SUBJECT: PLANS AND PROPOSAL ADDENDUMS

PROJECT: BR 2023(404)

CONTROL: 0035-04-039

PROPOSAL ADDENDUMS

US 83
TRAFFIC CONTROL PLAN
TYPICAL SECTIONS
HARDIN CREEK
07-048-0-0035-04-016
SHEET 1 OF 1

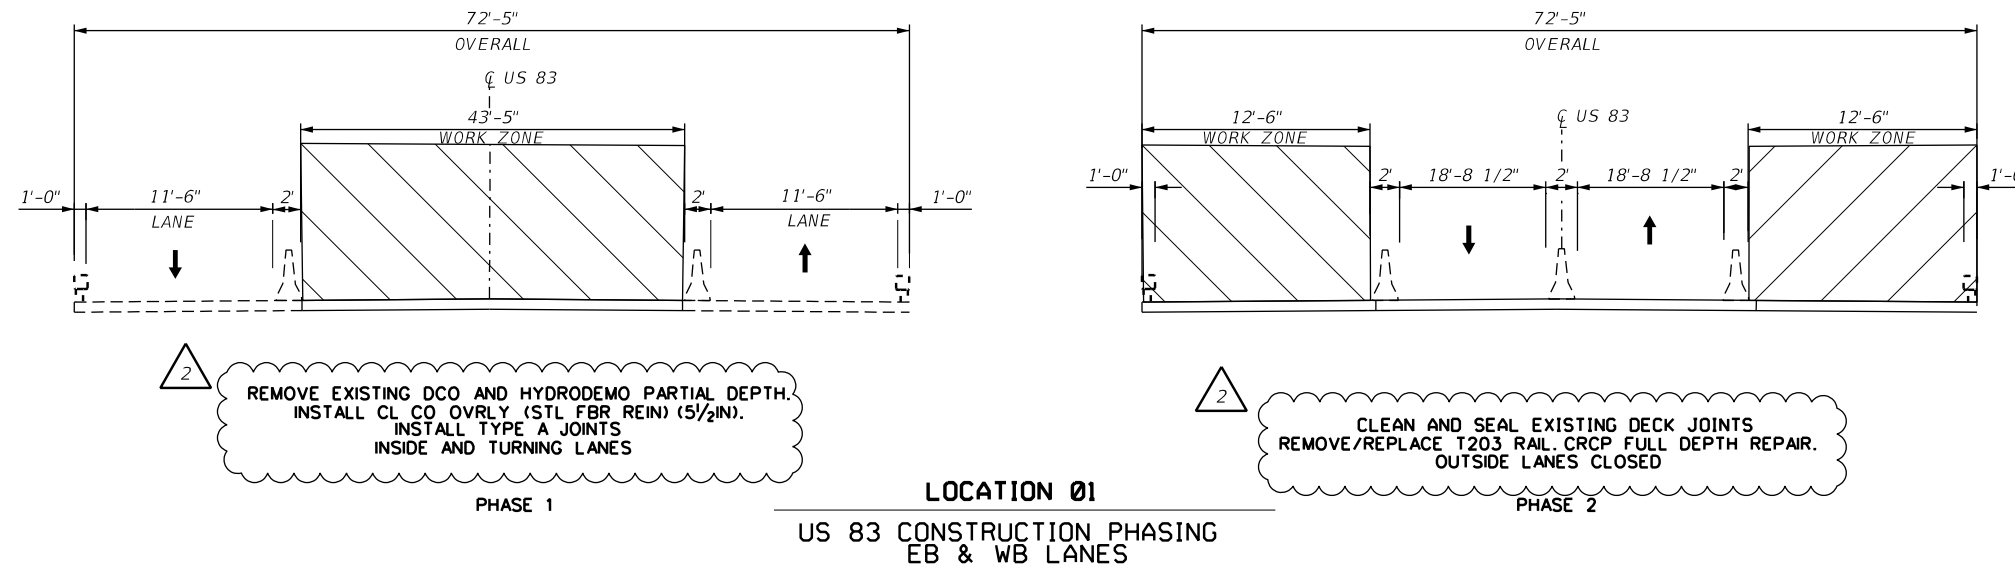
SHEET 5, 7: REVISED TRAFFIC CONTROL PLAN

1/27/2023	TCP TYPICAL SECTIONS REVISED	AP
NO	DATE	REVISION

2 REMOVE EXISTING DCO AND HYDRODEMO PARTIAL DEPTH. INSTALL CL CO OVRLY (STL FBR REIN) (5/2 IN). INSTALL TYPE A JOINTS INSIDE AND TURNING LANES

2 CLEAN AND SEAL EXISTING DECK JOINTS REMOVE/REPLACE T203 RAIL. CRCP FULL DEPTH REPAIR. OUTSIDE LANES CLOSED

US 83
 LOCATION 01
 LAYOUT
 HARDIN CREEK
 07-048-0-0035-04-016
 SHEET 1 OF 1

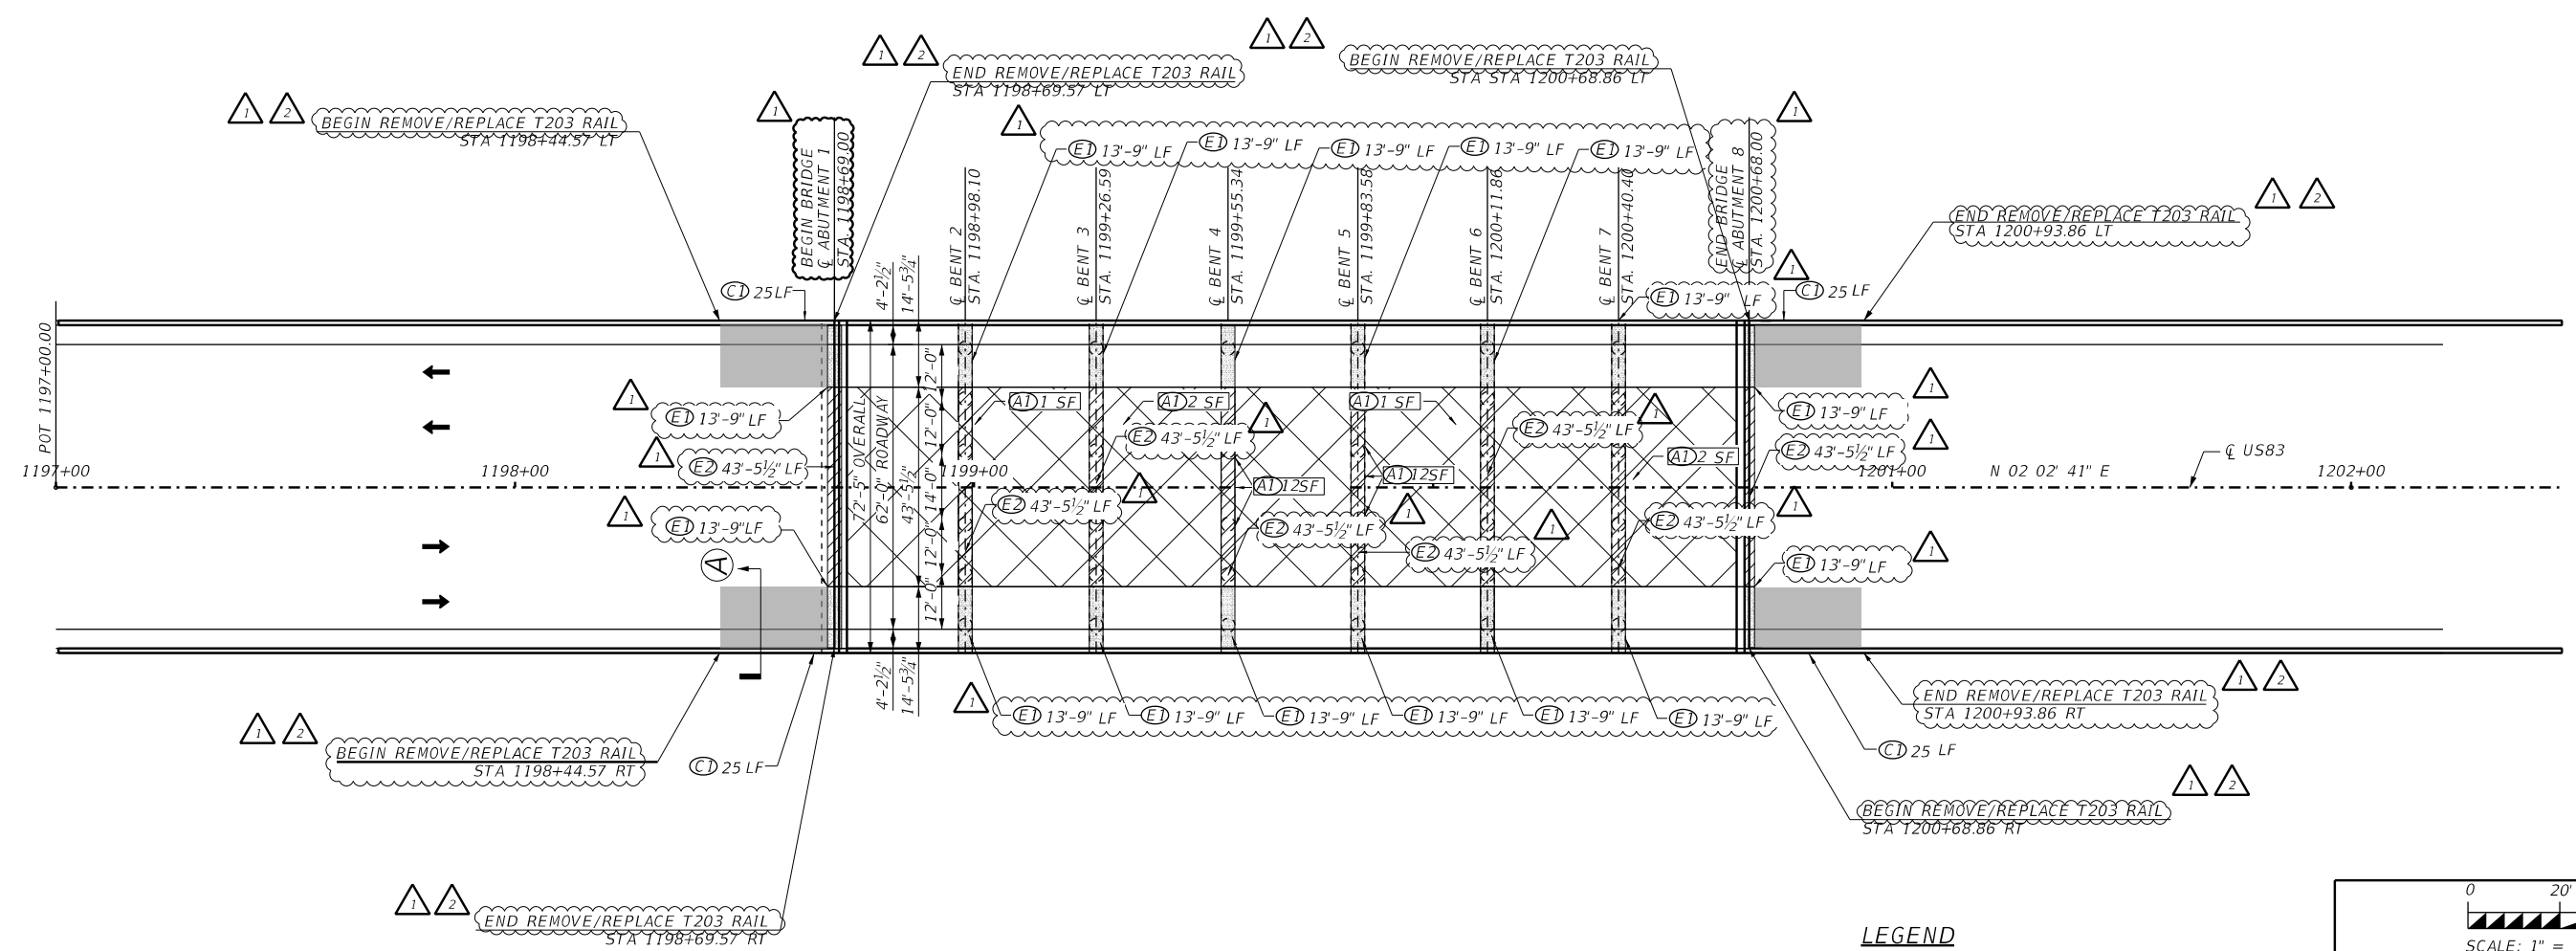
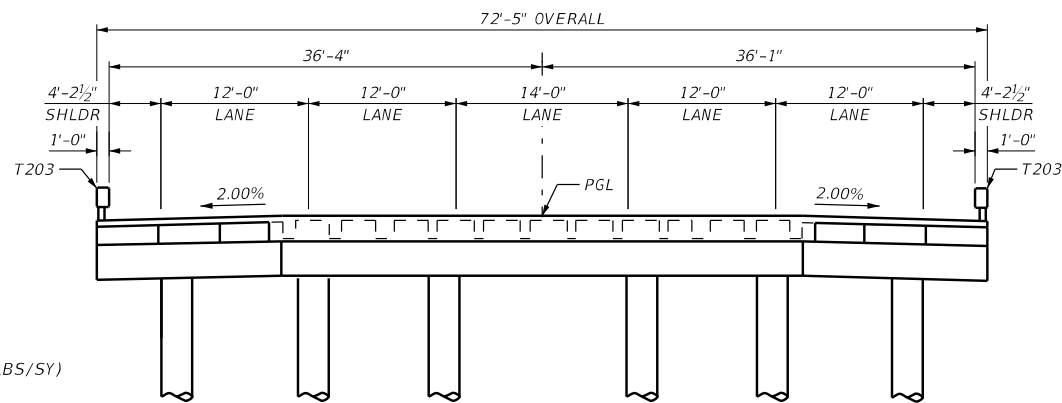
SHEET 25: REVISED RAIL REPAIR DETAILS

US 83
 LOCATION 01
 SUBSTRUCTURE REPAIR
 HARDIN CREEK
 07-048-0-0035-04-016
 SHEET 1 OF 1

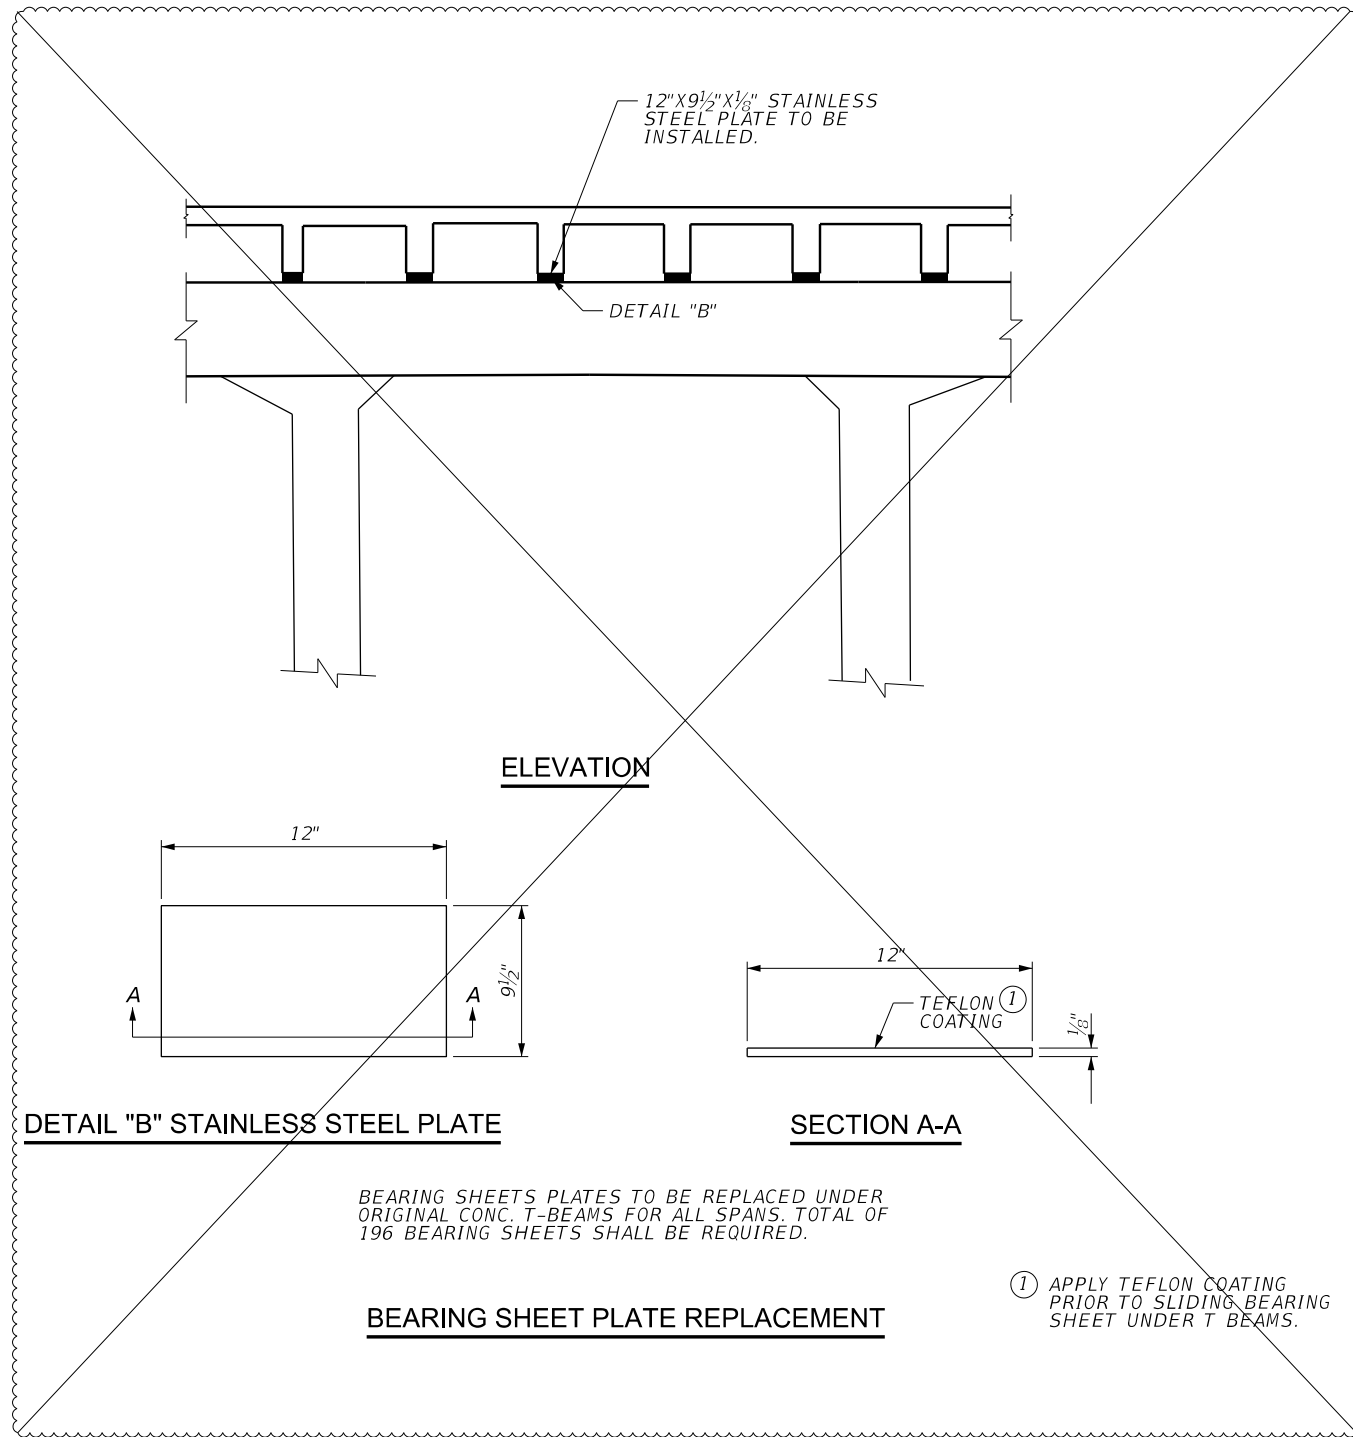
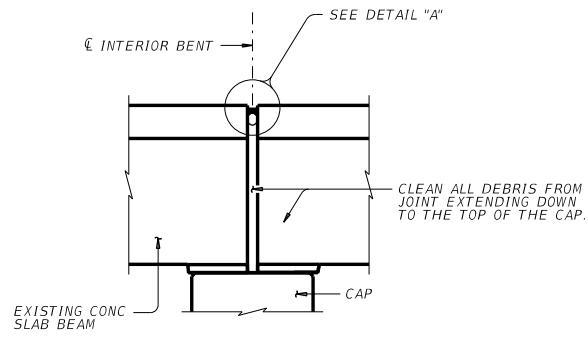
SHEET 26: REVISED SUBSTRUCTURE REPAIR DETAILS

NO.	DATE	REVISION	APPROV.
1	1/27/2023	CONC STR REPAIR AND SURFACE TREATMENT REVISED	AP

② ALL CONCRETE ELEMENTS IN SUBSTRUCTURE SHALL BE ITEM 428 6001 "PENETRATING SURFACE TREATMENT."

US 83
BRIDGE TYPE A JOINT REPAIR DETAILS
HARDIN CREEK
07-048-0-0035-04-016
SHEET 1 OF 1

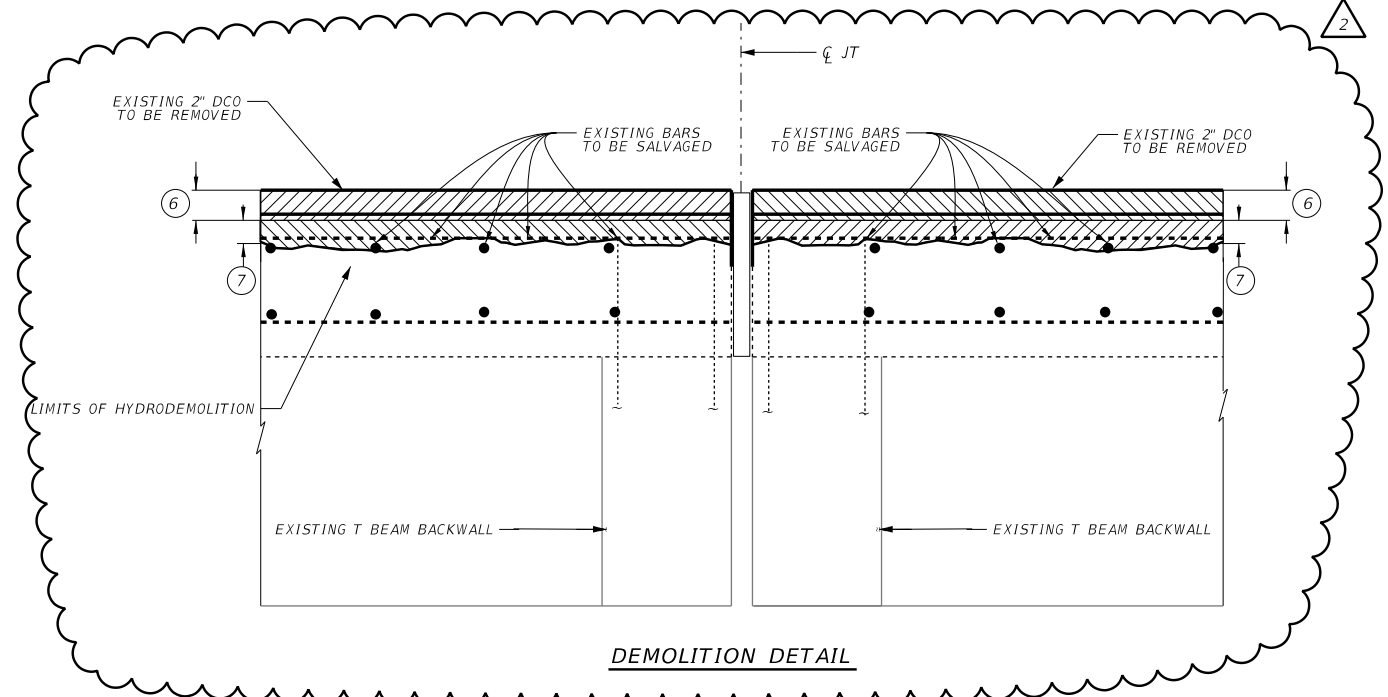
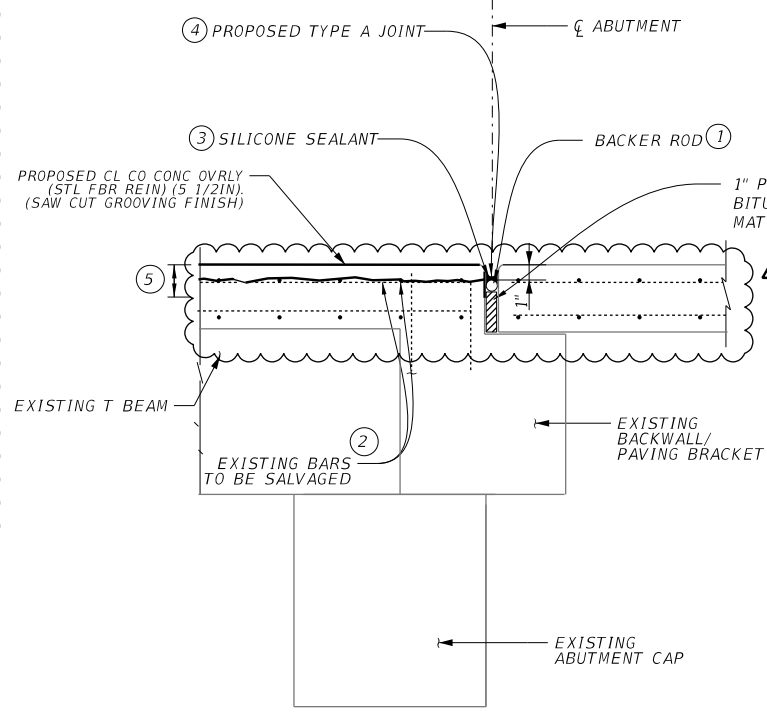
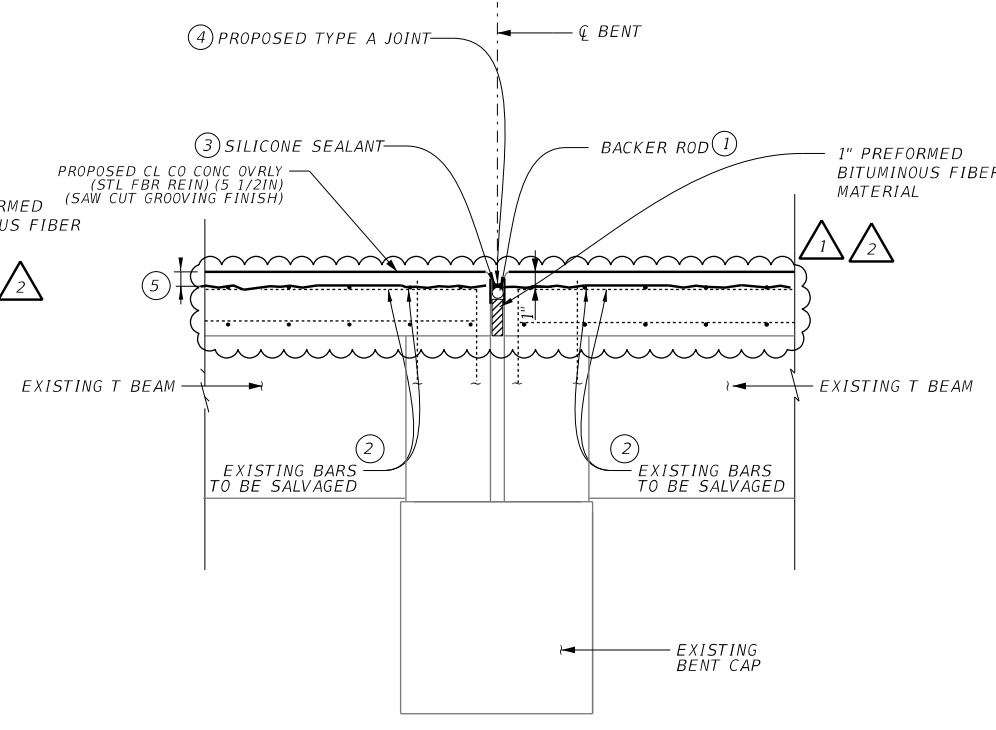
SHEET 30: REVISED JOINT DETAILS

NO.	DATE	REVISION	APPROV.
1	1/18/2023	JOINT REVISED	AP
2	1/18/2023	DCO, MILLING AND HYDRO-DEMOLITION REVISED	AP

- 5 NEW CL CO CONC OVRLY (STL FBR REIN) (5 1/2IN) SHALL MATCH EXISTING DECK ELEVATION. USE 40LBS/CY OF STEEL FIBER REINFORCEMENT SIZE=2 1/2" LONG.
- 6 REMOVE EXISTING 2" THICK DCO AND 1" OF EXISTING CONCRETE GIRDER TOP SLAB BY CONCRETE MILLING. USE CONCRETE MILLING EQUIPMENT CAPABLE OF MAINTAINING CONSTANT DEPTH OF CUT SPECIFIED. EQUIPMENT MACHINE WITH AUTOMATED DEBRIS COLLECTION SYSTEM.

- 7 REMOVE DAMAGE AND LOOSE CONCRETE BY HYDRODEMOLITION. UNTIL SOUND CONCRETE IS REACHED. AVOID DAMAGE TO SOUND CONCRETE.
